**ATTACHMENT 1A**

**Emergency Plan Marked-up Pages – Braidwood Station**

Exelon Standardized Emergency Plan EP-AA-1000  
and  
Emergency Plan Annex EP-AA-1001

**Exelon Standardized Emergency Plan EP-AA-1000**

Figure B-1a: Exelon Overall ERO Command Structure

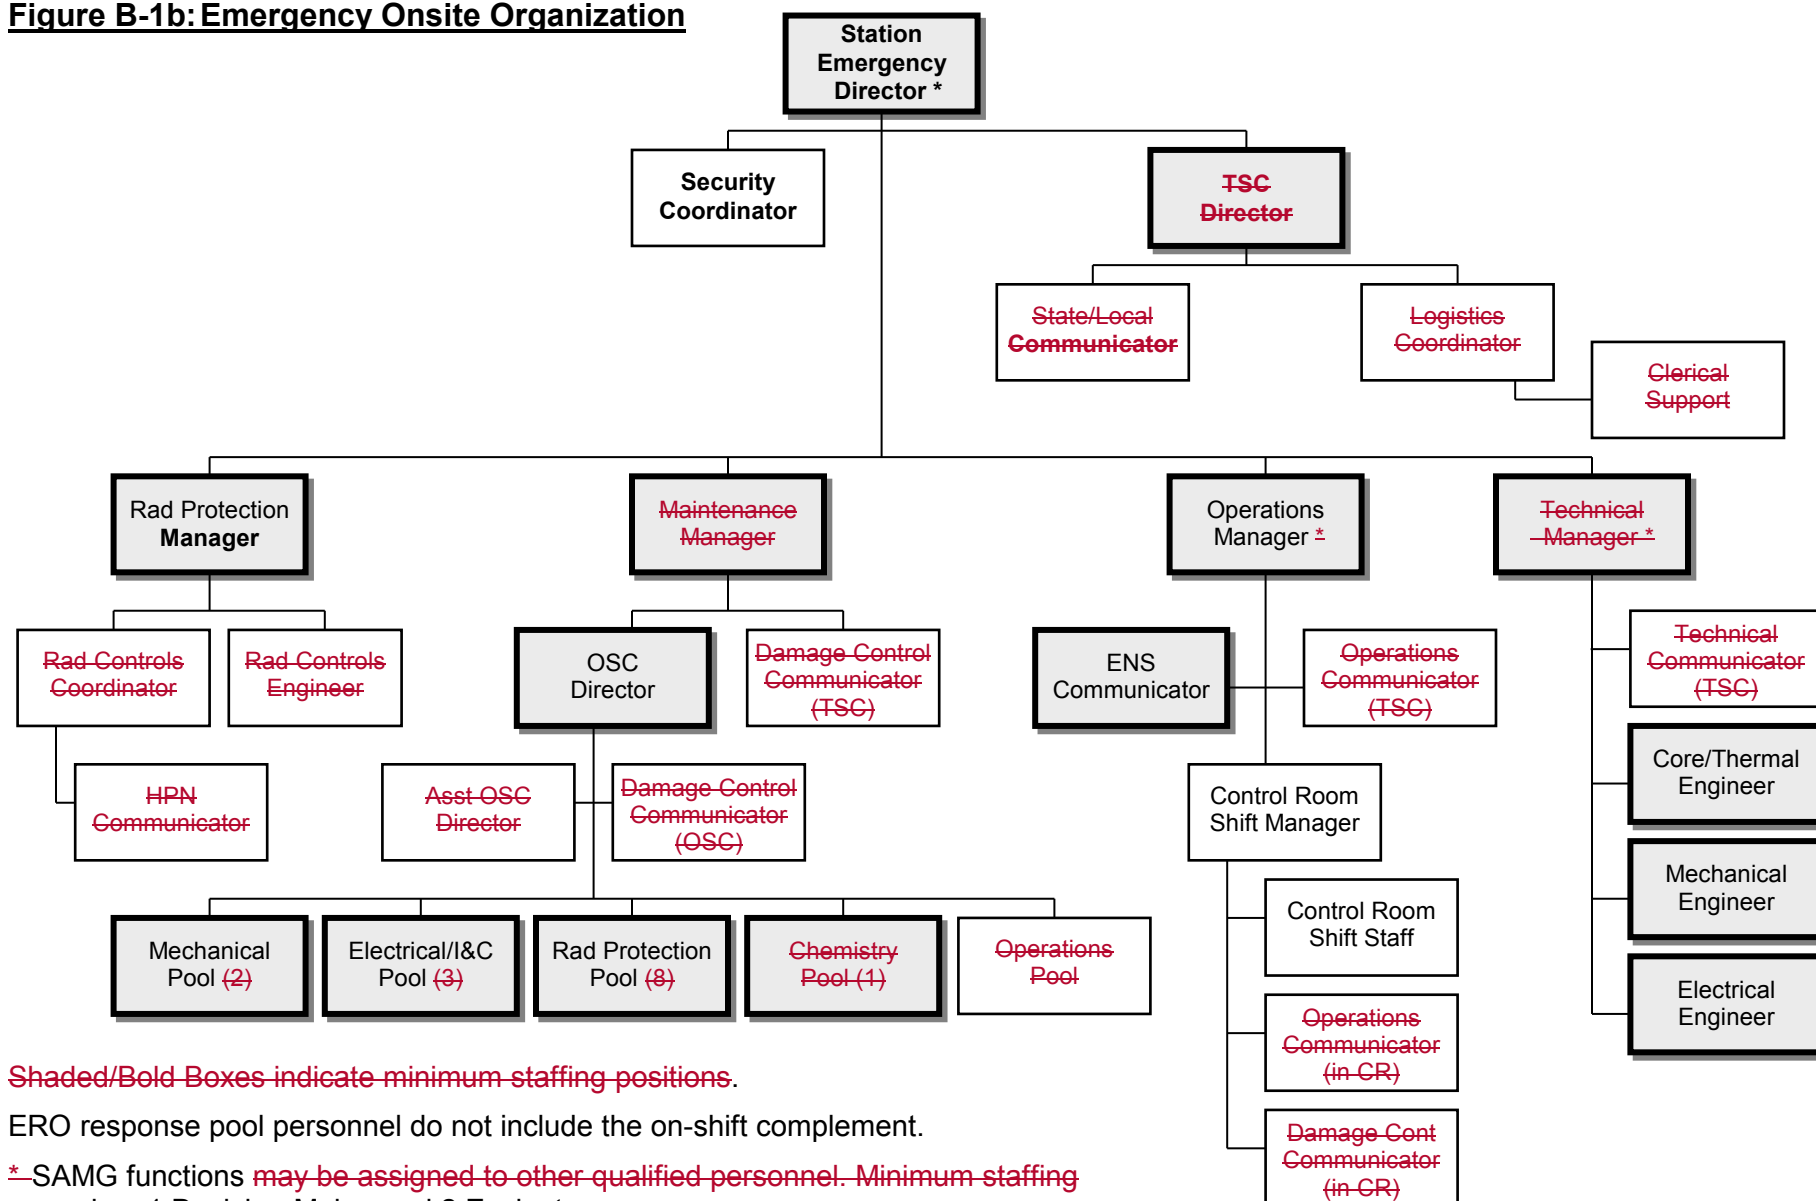
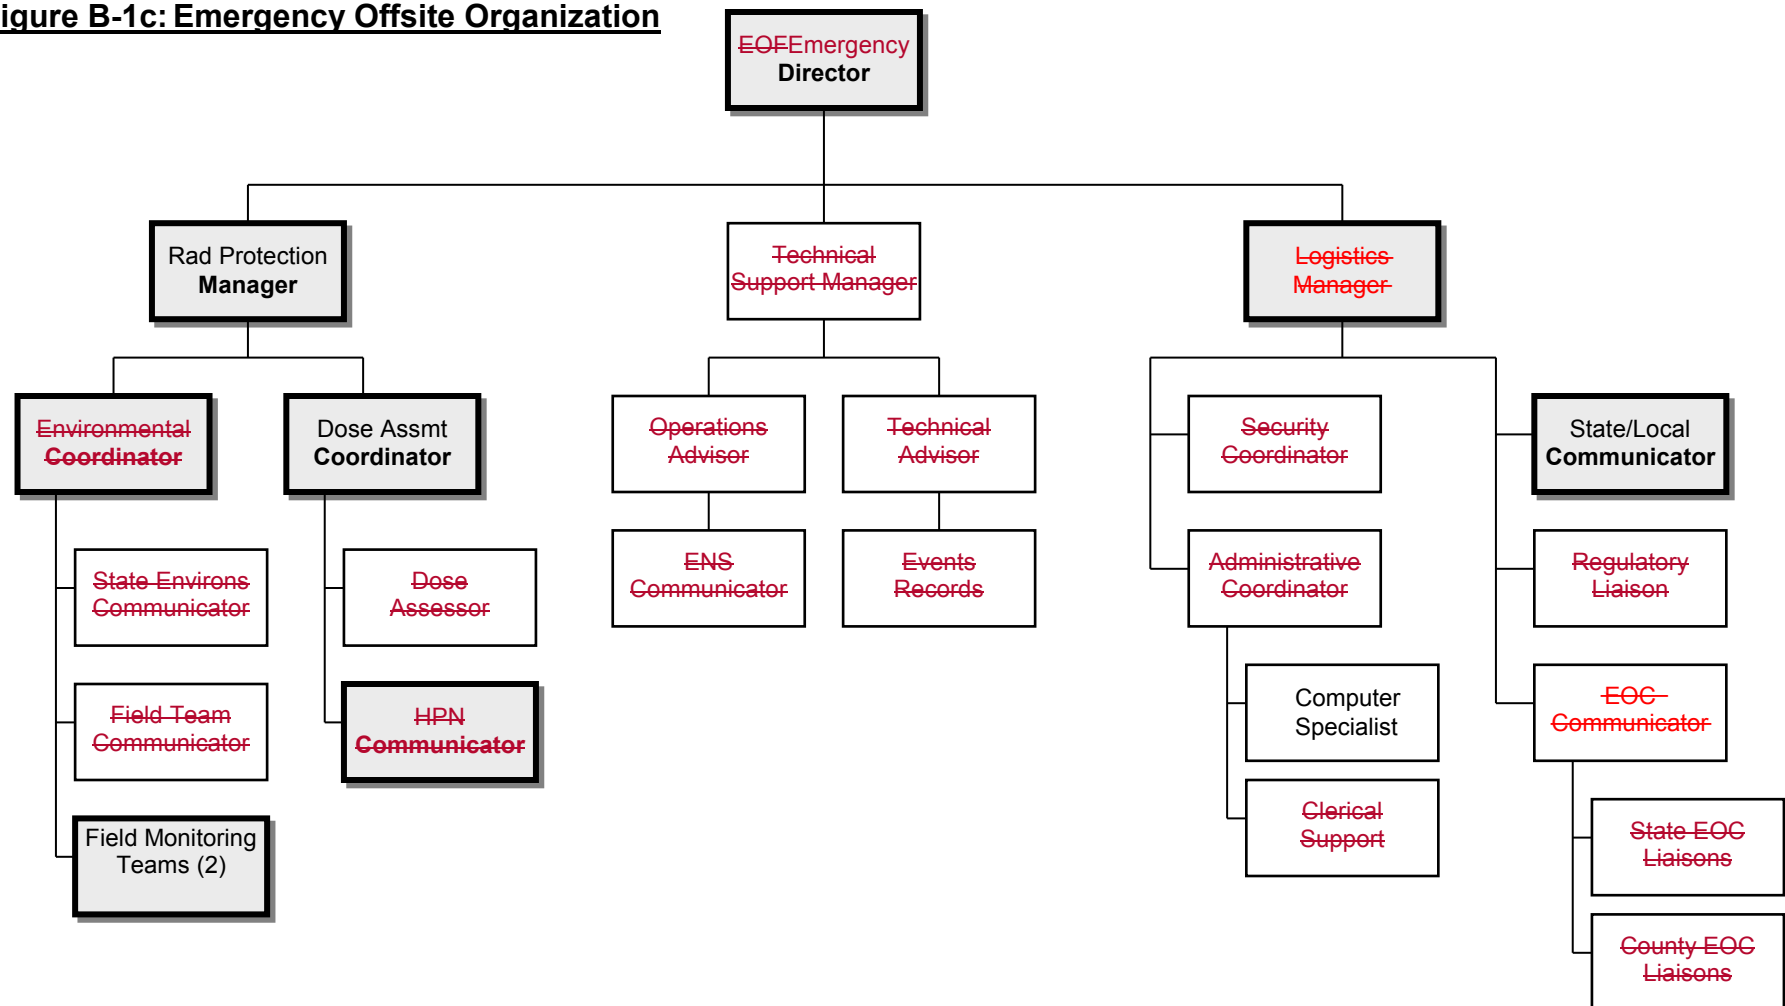
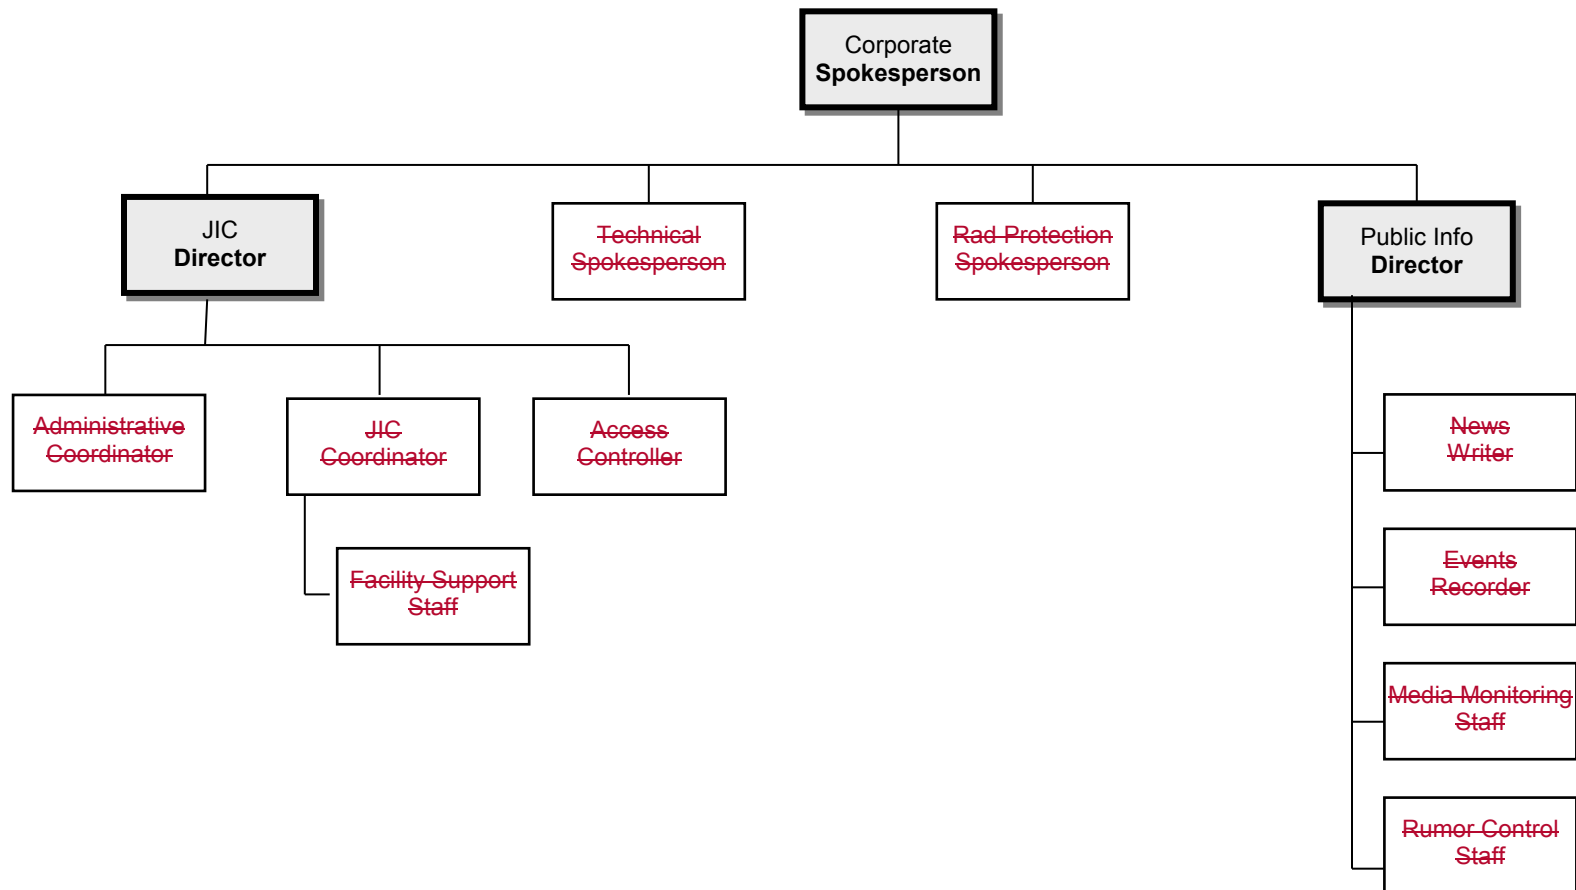
ERO staffing tables contained ~~within the station specific Annexin Appendix 5,~~ lists the key positions of the ERO ~~and the supporting positions assigned to interface with federal, state, and county authorities.~~ Figures B-1a through B-1d illustrates the overall emergency response organization. Section B.5 discusses specific responsibilities and the interrelationships for key positions.
